BASE-048

深圳市捷达成电子有限公司

SHENZHEN JIEDACHENG ELECTRONICS CO.,LTD.
TEL:0755-27317730 FAX:0755-27317731ANGLE:
+/-1°UNIT:
MMSCALE:
4/1MODEL NAME:
BASE-048UL REC:
UL 94V-0PIN TENSION LOAD:
1.8KG MINDATE:
2019-09-30BOBBIN MATERIAL:
PM-9823PIN MATERIAL:
CP WIREDRAWING NO:
BASE-048REV:
1.0

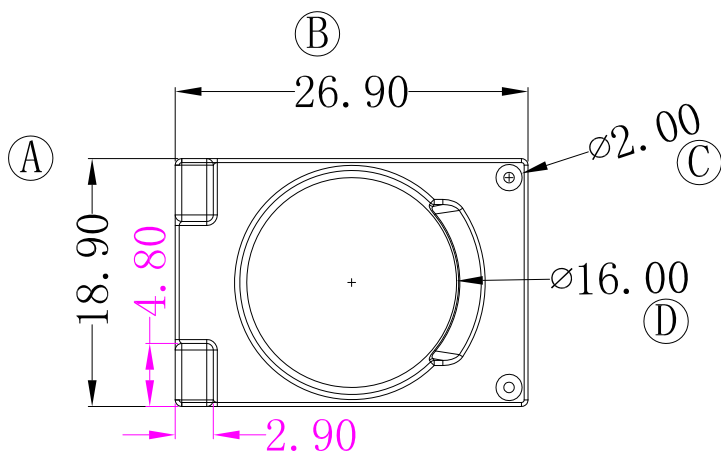
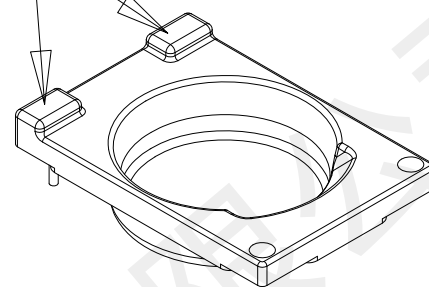
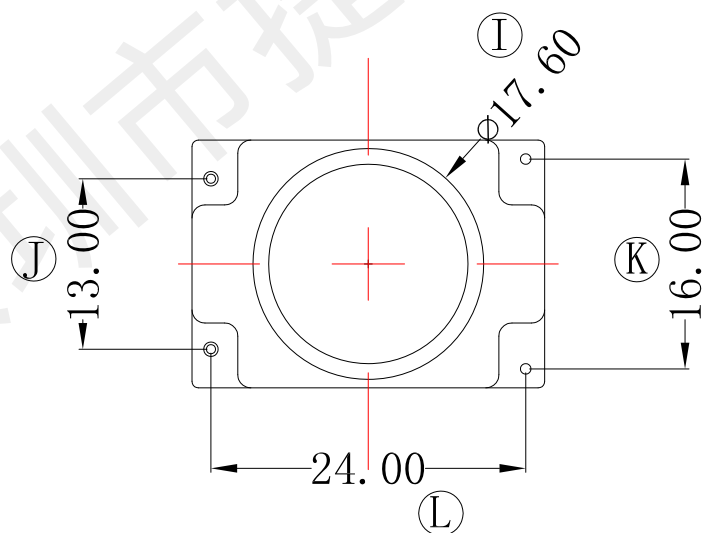
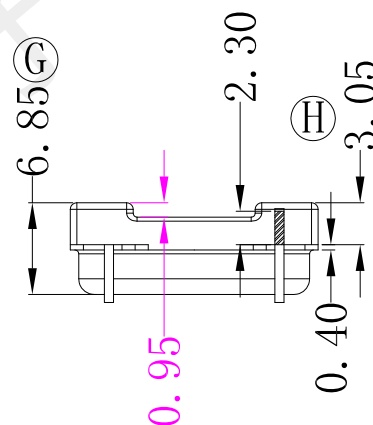
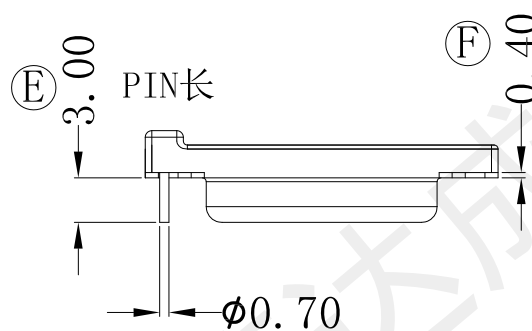
一: 针脚顶部增加
两个凸点插针深度
2.30+/-0.2

REV	DATE	REVISIONS REC
1	20-3-2	第一位置增加两个凸点, G尺寸由5.9改为6.85, H尺寸由2.5改为3.05
